Cost/Benefit Analysis for CSNDC Schedule 4D

Prepared by Christchurch City Council (CCC)
Prepared for Environmental Canterbury (ECan)
Dated 22 July 2021

Appendix B - Technical Review of Cost/Benefit Analysis for CSNDC Schedule 4D

Prepared by Technical Peer Review Panel (TPRP)
Prepared for Christchurch City Council (CCC)
Dated 8 July 2021

Figure 12 NPV cost per amount of TSS removed annually

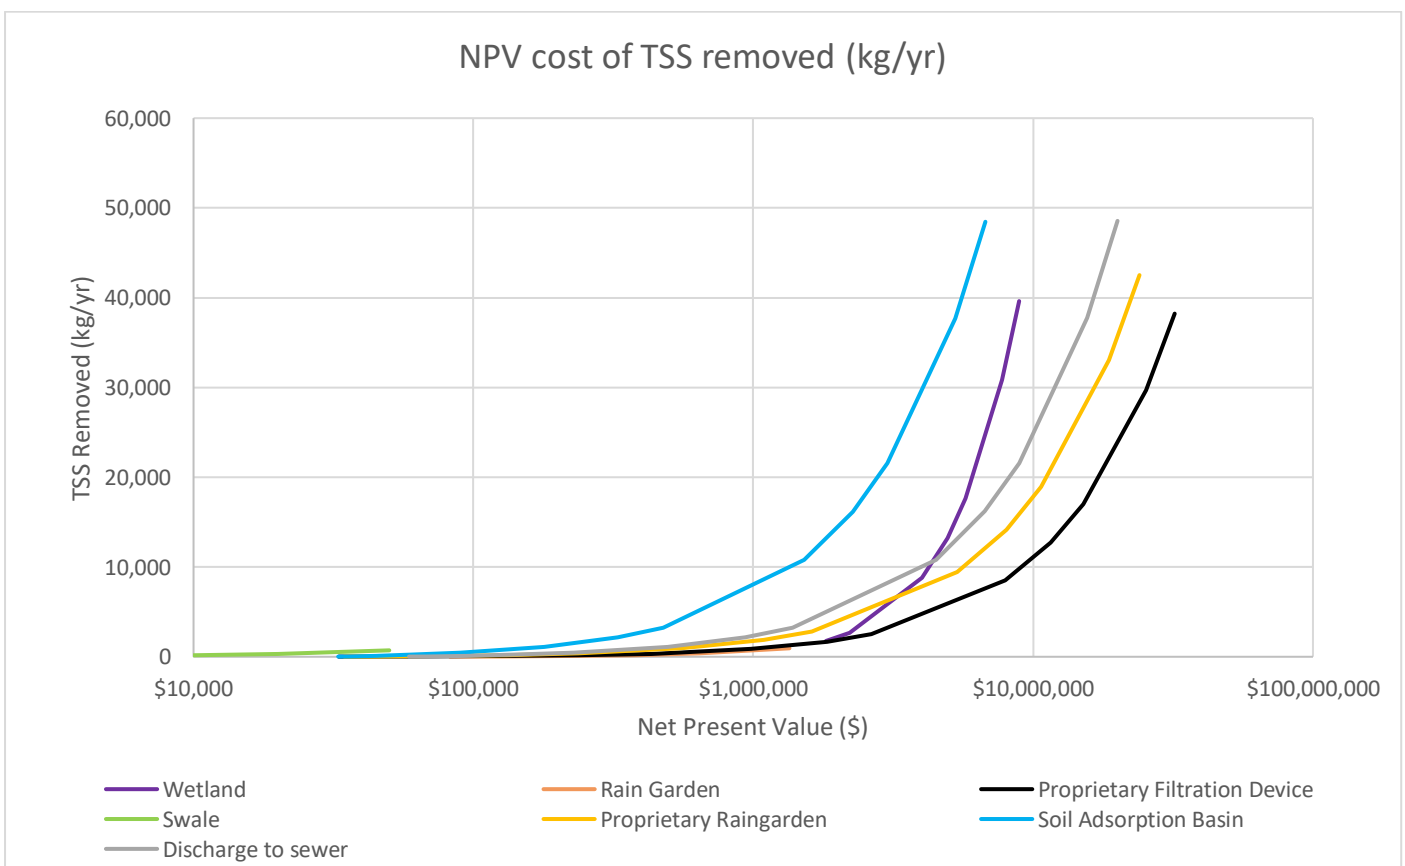
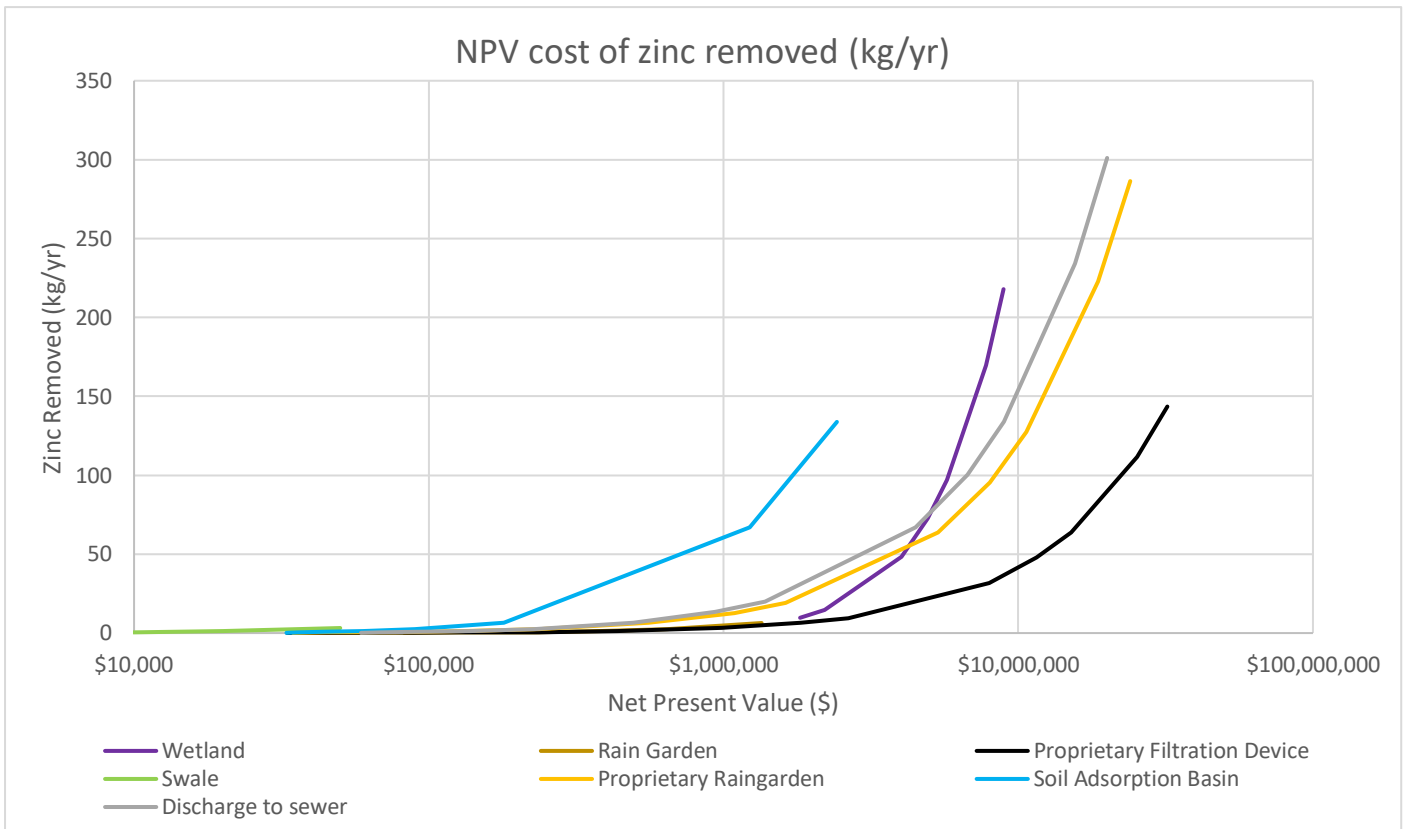
- Please check the axes on the graphs in Figures 12 and 13 – the y-axis includes \$ values yet references kg/yr, x-axis has no \$ sign next to the numbers. Makes it slightly confusing to read. Also please check the cost of the PFD referenced in the text: PFD in Figure 12 looks to be around \$20 million? Is it perhaps supposed to reference discharge to sewer, which is closer to \$9 million?
